AMENDMENT NO. 1 JANUARY 1991
TO
IS 11937 : 1987 SPECIFICATION FOR CARBIDE TIPPED MACHINE
JIG REAMER WITH MORSE TAPER SHANK

TABLE 1 DIMENSIONS FOR CARBIDE TIPPED MACHINE JIG REAMER WITH MORSE TAPER SHANK

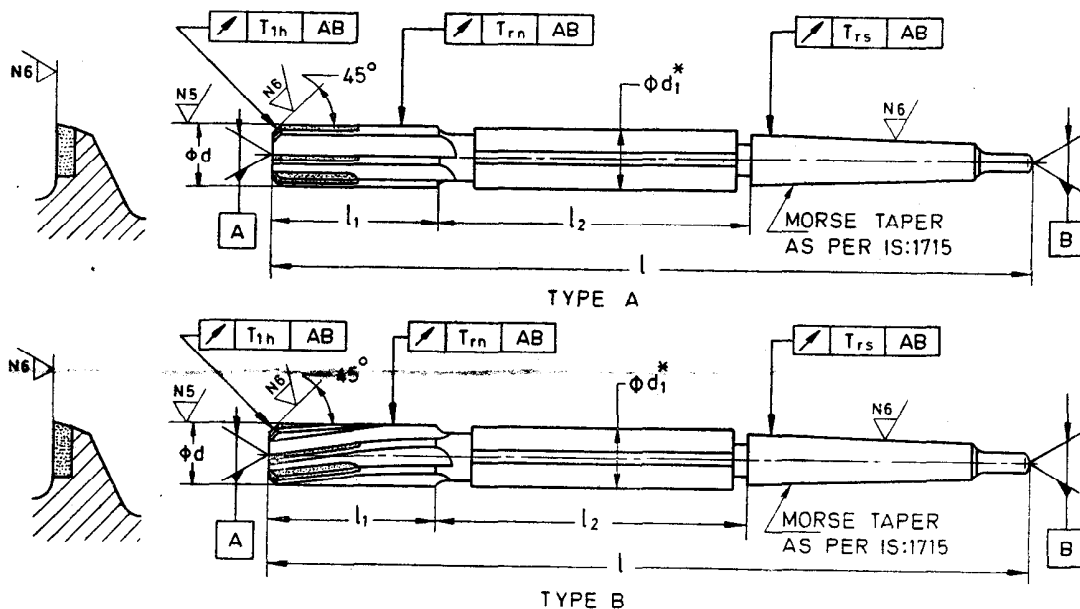
(Page 2, Table 1) — Substitute the following for the existing table:

d m6	Range of Diameter		l ₁	l ₂	l	Morse Taper	No. of Flutes	Carbide Tip
	Over	Up to and Including						
7.0	6.7	7.5	31	53	150	1	4	R 16
8.0	7.5	8.5	33	57	156			
9.0	8.5	9.5	6	60	162			
10.0	9.5	10.6	38	64	168		6	R 19
11.0	10.6	11.8	41	68	1			
12.0	11.8	13.2	44	72	132			
(13.0)			44	72	182			
14.0	13.2	14.0	47	76	189

d m6	Range of Diameter		l ₁	l ₂	l	Morse Taper	No. of Flutes	Carbide Tip	
	Over	Up to and Including							
(15·0)	14·0	15·0	50	74	204	2	6	R 19	
16·0	15·0	16·0	52	78	210			R 22	
(17·0)	16·0	17·0	54	80	214				
18·0	17·0	18·0	56	83	219				
(19·0)	18·0	19·0	58	85	223				
20·0	19·0	20·0	60	88	228				
(21·0)	20·0	21·2	62	90	232			R 25	
22·0	21·2	22·4	64	93	237				
(23·0)	22·4	23·6	66	95	241				
(24·0)	23·6	25·0	68	101	268	3	8		R 30
25·0			68	101					
(26·0)	25·0	26·5	70	104	273				
(27·0)	26·5	28·0	70	104					
28·0			71	107	277				
(30·0)	28·0	31·5	73	109	281				
32·0	31·5	33·5	77	116	317				
(34·0)	33·5	35·5	78	119	321				
(35·0)			78	119	321				
36·0	35·5	37·5	79	122	325	4	10		
(38·0)		40·0	81	124	329				
40·0			81	124	329				
(42·0)			82	127	333				
(44·0)	42·5	45·0	83	129	336				
45·0			83	129	336				
(46·0)	45·0	47·5	84	132	340				
(48·0)	47·5	50·0	86	134	344				
50·0			86	134	344

*The diameter d_1 shall be equal to the diameter of the reamer with a tolerance of h6. However, the actual diameter d_1 shall not exceed diameter d .
